JRPP No	2010NTH027
DA Number	2010/234
Local Government Area	Nambucca Shire Council
Proposed Development	Proposed new primary school
Street Address	Lot 11 DP 805157, Dudley Street, Macksville
Applicant	Simon Waterworth, GeoLINK Pty Ltd.
Number of Submissions	1
Recommendation	Refusal
Report by	Arthur Tsembis, Manager Planning & Assessment, Nambucca Shire Council

Assessment Report and Recommendation

Figure 1. ARR Project 10 Hazard with hazard values for St Patricks as calculated by ADW Johnson

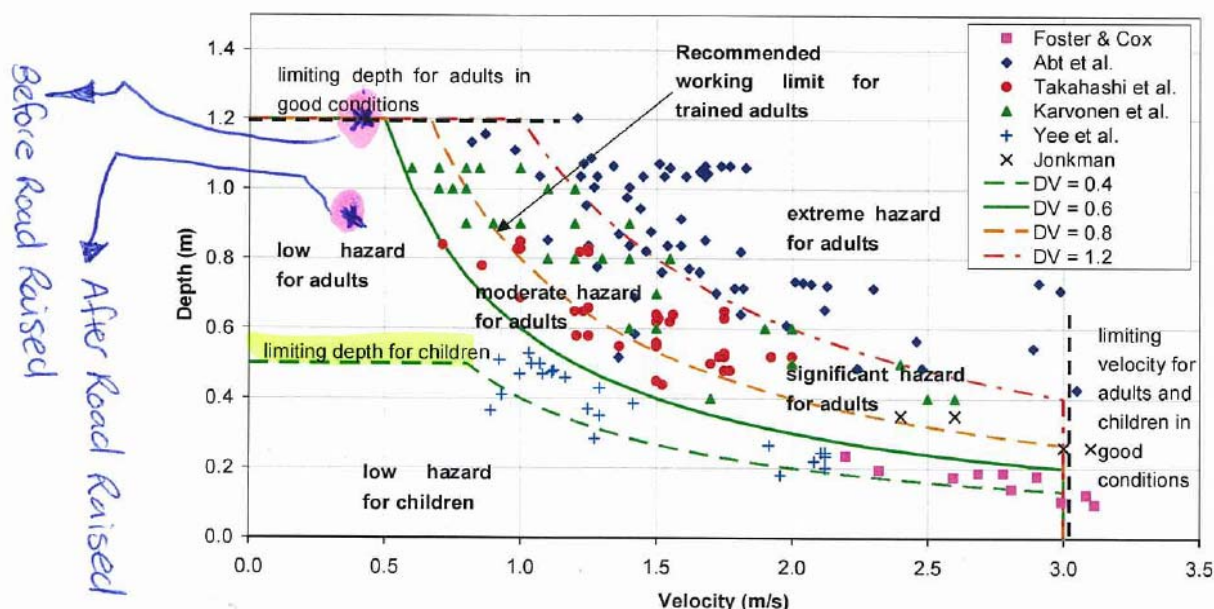
ADW Johnson have misunderstood the Australian Rainfall and Runoff (ARR) Project 10 hazard categories. Figure 1 below shows the hazard as calculated by ADW Johnson using “average” velocities before and after the road is raised. Table 2 is the ARR Project 10 hazards as a table. Note that 0.5m is a limiting depth for children. This would place the before raising case as extreme hazard for adults and the after raised case as Low hazard for adults (and therefore significant hazard to children, dangerous to most).
